Nampa Wastewater Treatment Plant Phase I Upgrades: Group A-Liquid Stream Upgrades

Response to Written Bidder Questions – Addendum 5

## **EXISTING PUMP DATA**

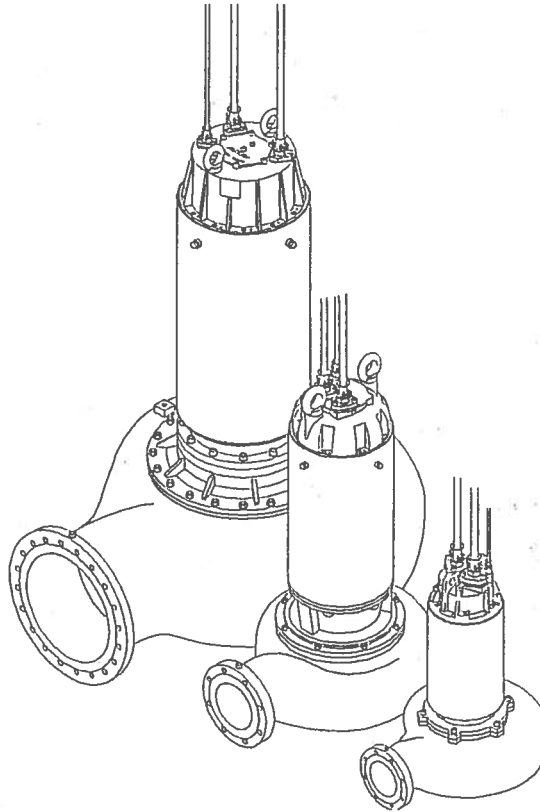
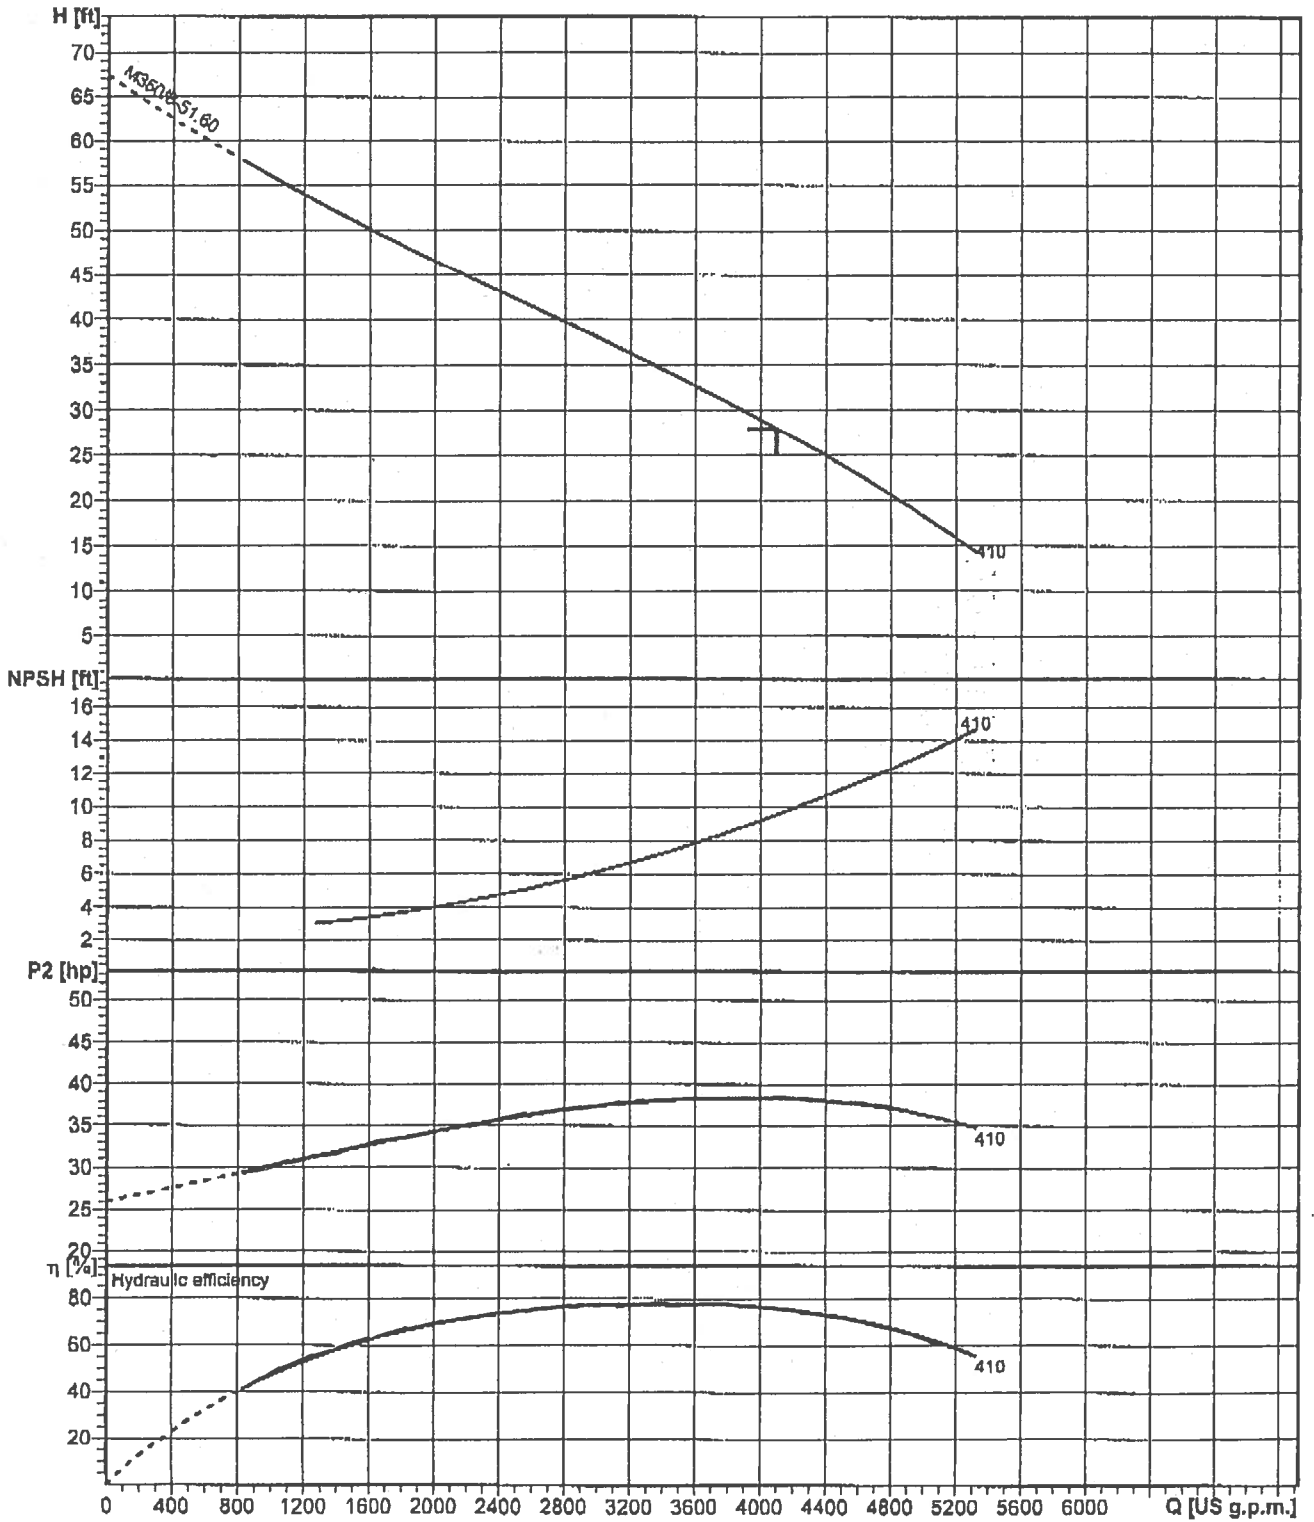
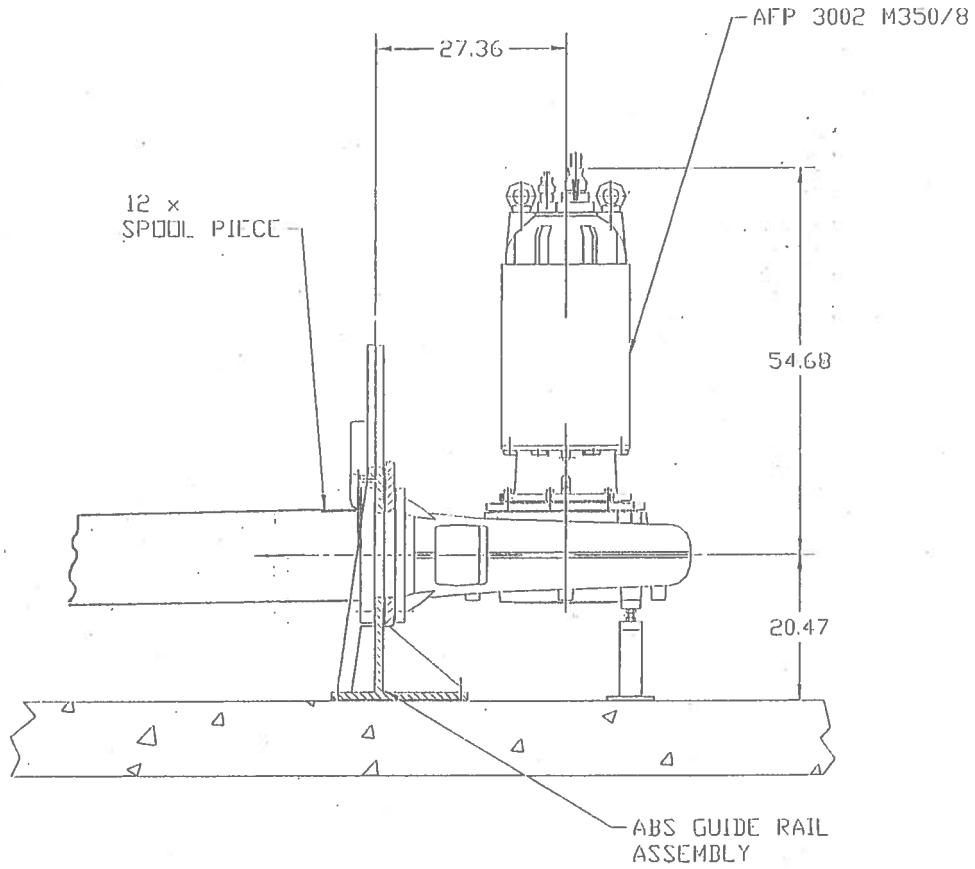
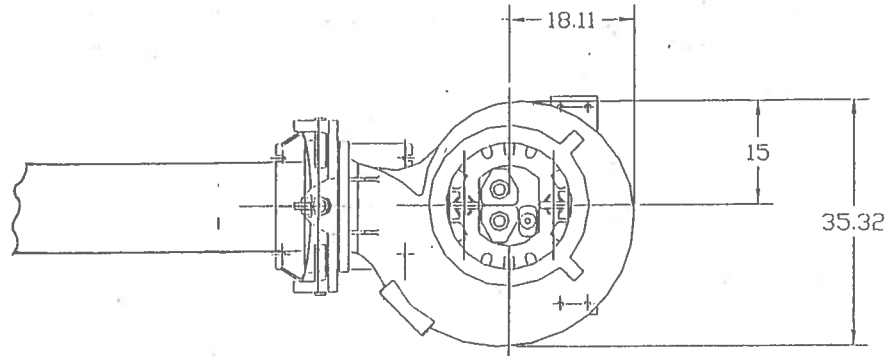
<b>37</b>	01 57 28	Can you supply us with the pump performance data and pump curves for the existing submersible pumps currently installed in the TFEPS wet well?	See Addendum 5 for these curves.
